TOWN OF HUDSON

PUBLIC MEETING TOWN OF HUDSON, NH MARCH 14, 2018

2 Friel Golf Road (Steele Hill Farm) Site Plan Review

Town of Hudson Planning Board Review Steele Hill Farm, LLC, Site Plan, 2 Friel Golf Road Tax Map 234, Lot 1; Acct. #1350-910 CLD | Fuss & O'Neill Reference No. 03-0249.1690

DRAWING NAME: 3867SF-EC31 2 OF 7 3867-SF

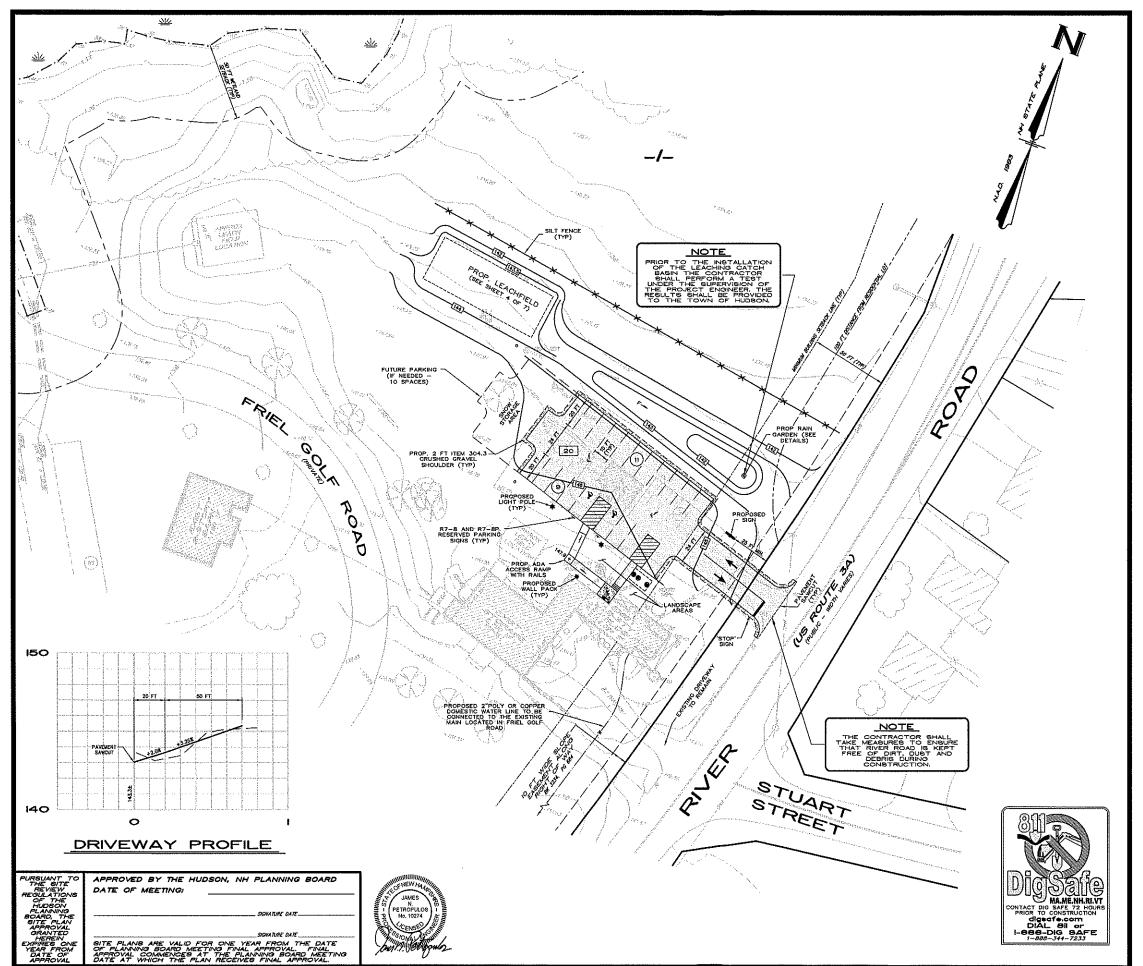
- The existing 4,024 sqft building known as Front Building is existing non-conforming in regards to building front setbacks and any expansion of footprint would require variance to §334-31A from the ZBA.
- 2) Sheet 3 of 7 indicates installation of a free standing sign. Sign must include correct street number, as it appears access is off of River Road. Does this free standing sign violate §334-64?: Freestanding business and industrial signs: "...each individual site may have no more than one freestanding pole or ground sign, not attached to any building." There is already a free standing sign advertising the golf/ski shop at corner of Friel Golf Rd and River Road on this lot. Thus a variance from §334-64 from the ZBA would be required to install this additional sign.

- 1f. See revised cover sheet.
- 1g. Sheet 3 of 7 has been revised to show a 100-foot distance from the nearest residential lot in the vicinity of the proposed work.

- 5f. See sheet 3 of 7 for the revised snow storage area location.
- 5q. See sheet 7 of 7 for the revised rain garden typical section that addresses this comment.

- 6a. No response required.
- 6b. No response required.
- 6c. No response required.
- 6d. See sheet 3 of 7 for the added dimension from the sign to the right-of-way.
